**FINAL  
ENVIRONMENTAL ASSESSMENT/  
ENVIRONMENTAL IMPACT REPORT**

**EAGLE CANYON  
DAM AND DEBRIS BASIN**

**RIVERSIDE COUNTY FLOOD CONTROL AND  
WATER CONSERVATION DISTRICT**

**RBF CONSULTING**

**AGUA CALIENTE INDIAN RESERVATION**  
**T4SR5E, SECTION 32**  
**EAGLE CANYON DAM PROJECT**

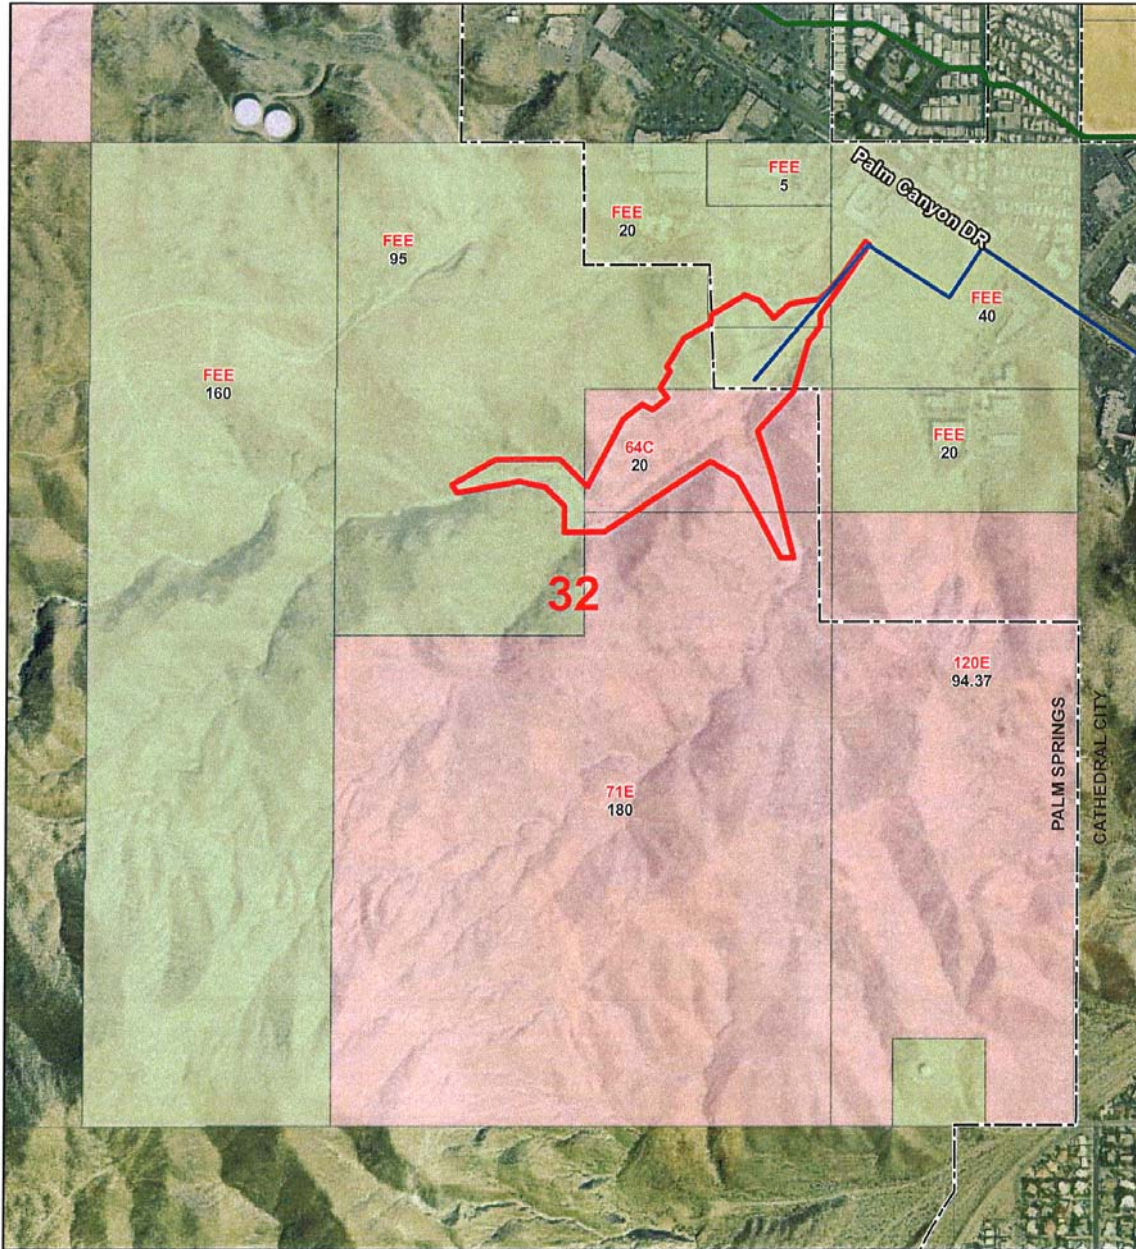
Thank you for the opportunity to comment on the Eagle Canyon Dam & Debris Basin Draft EA/EIR. The boundaries of the Agua Caliente Indian Reservation ("Reservation") are incorrectly identified throughout the EA/EIR. Expanded in 1876 by President Rutherford B. Hayes, the boundaries of the Reservation include all of the even numbered sections (excluding 16 and 36) in Township 4 South, Range 4 East, Township 4 South, Range 5 East, and Township 5 South, Range 4 East of the San Bernardino Base and Meridian (SBBM). This checkerboard pattern includes different forms of landholdings including Tribal Trust Land, Allotted Trust Land, and Fee Land.

With regard to the Eagle Canyon Dam & Debris Basin Project, the entire Project Area lies within Section 32 of Township 4 South, Range 5 East of the SBBM; therefore, the entire project is located within the boundaries of the Reservation on Allotted Trust and Fee Land (see enclosed map). It is incorrect to assume that land sold out of Trust to non-Indians in Fee removes it from the boundaries of the Reservation. Only an Act of Congress or Executive Order can add or remove land from the Reservation.

Since the entire Eagle Canyon Dam & Debris Basin Project is located within the boundaries of the Reservation, the entire Project is subject to the requirements of the Tribal Habitat Conservation Plan, not the Coachella Valley Multiple Species Habitat Conservation Plan. The analysis contained in Section 3.3, *Biological Resources*, needs to be updated accordingly.

- 2.1 Clarification has been added to Chapter 3.3, *Biological Resources*, of the Draft EA/EIR. Refer to Section 3.0, *Errata* of this Final EA/EIR. However, it should be noted, that the entire project site is not located within Section 32 of Township 4 South, Range 5 East of the San Bernardino Base and Meridian (SBBM) as indicated in this letter. A portion of the proposed Line 43 is located outside of Section 32, as shown on the previous exhibit attached to Comment Letter No. 2.

**Page 3.10-9**

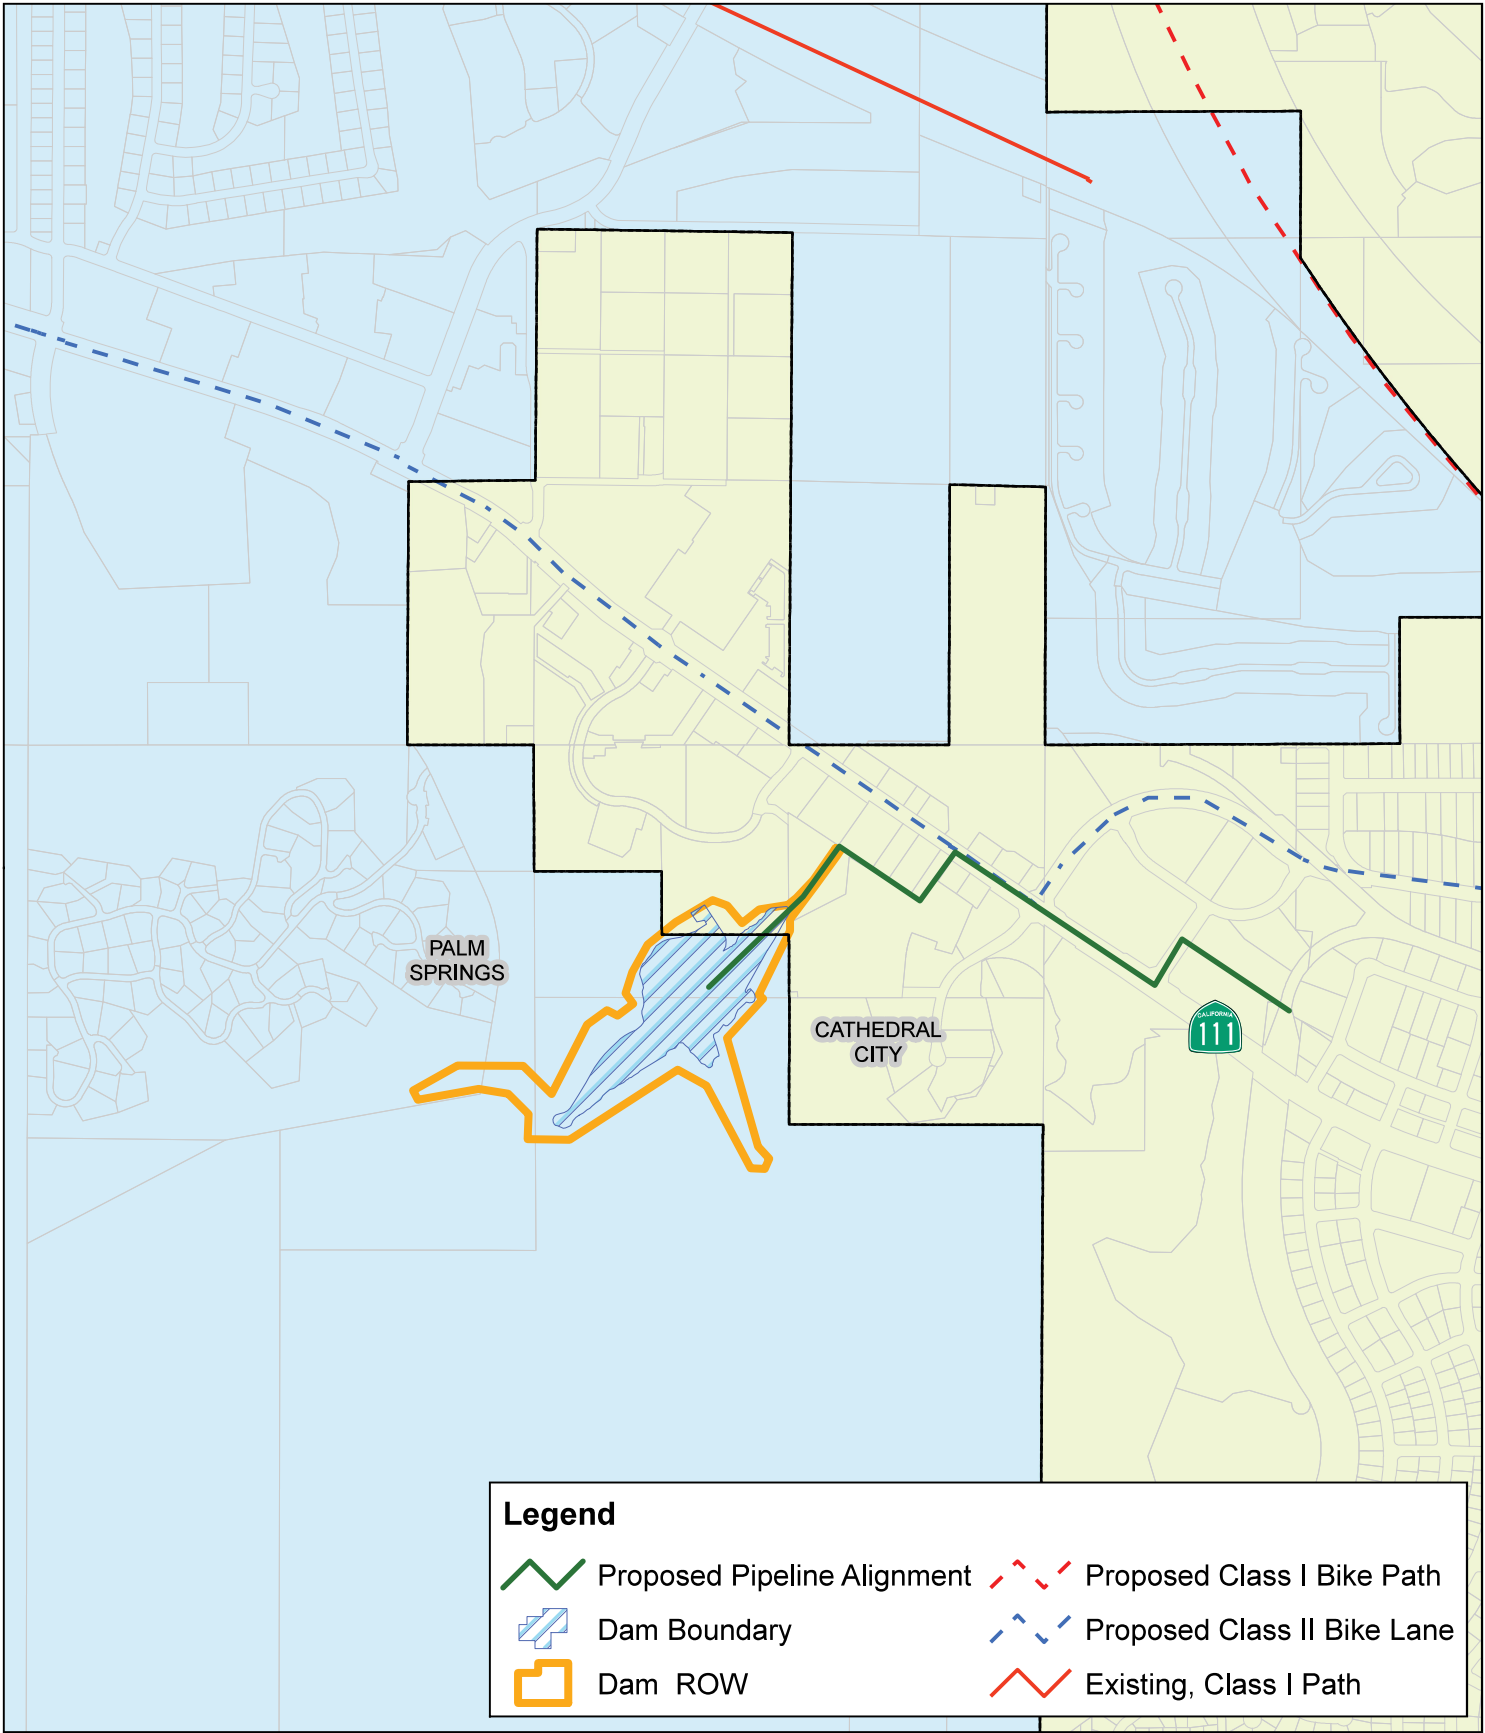
However, according to GIS data acquired from the Coachella Valley Association of Governments (CVAG), a Class III designated bike lane is proposed within the right-of-way of Highway 111 (refer to Exhibit 3.10-1, *Bicycle Path Map*).

[The existing hiking trail was removed from Exhibit 3.10-1, after site visits confirmed that no trails exist on site.]
